Application Number:	PL/2026/02472
Location:	Land Rear of 117, High Street, Dilton Marsh
Proposal:	Reserved Matters Application for Landscaping, Appearance, Layout and Scale for 54 dwellings following outline planning permission PL/2023/01880 approved at appeal (APP/Y3940/W/24/3352160)

The following comments (in **red**) are made in respect of the revised plans submitted in response to consultee responses on the initial submission.

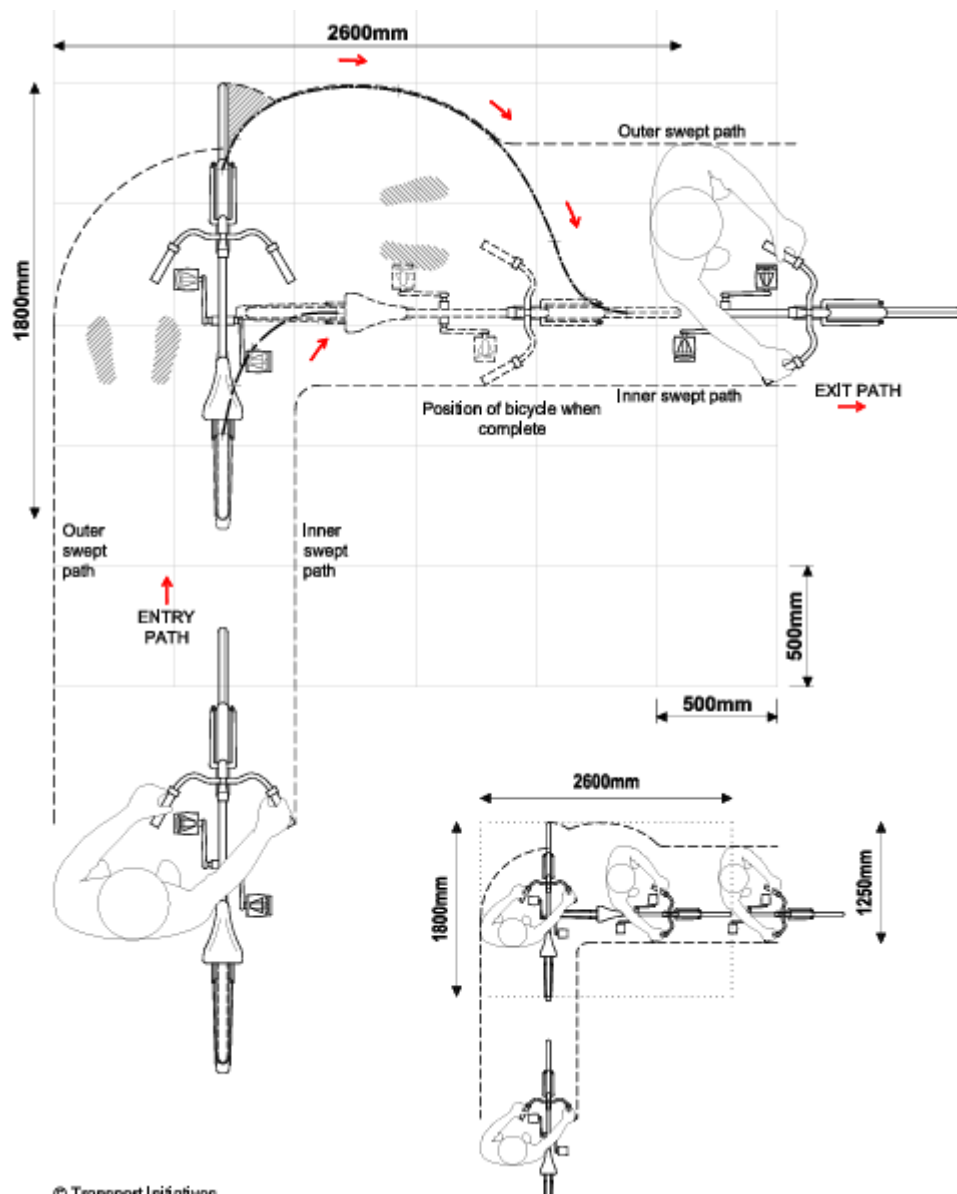
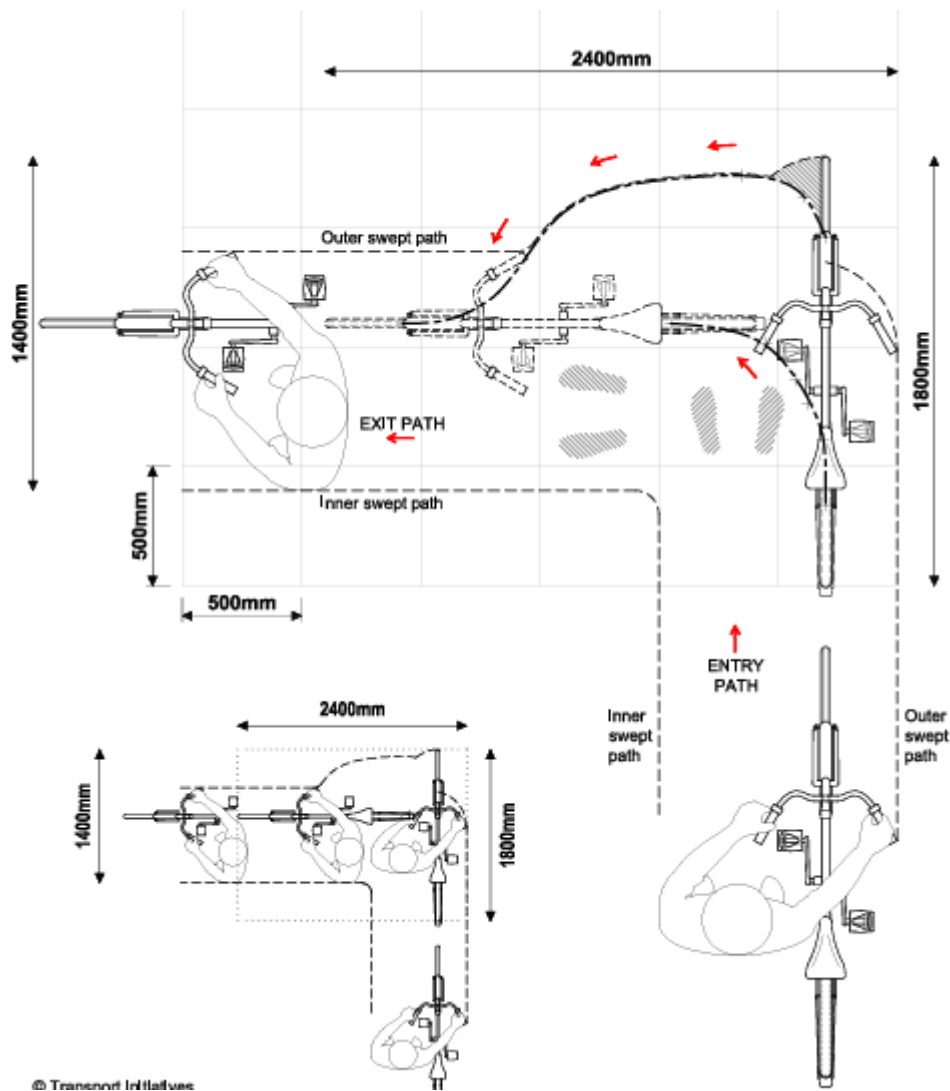
The cycle storage sheds for plots 18 and 19 are not appropriately located to provide ease of access to the rear garden gate, with the storage shed being located on the opposite side of the garden. This has been addressed in the revised layout.

The access route to the cycle storage shed for Plots 44 and 45 is tortuous, and the limited width would make it difficult and potentially a disincentive to cyclists to use, contrary to sustainable travel. See details below of access requirements. This has not been addressed.
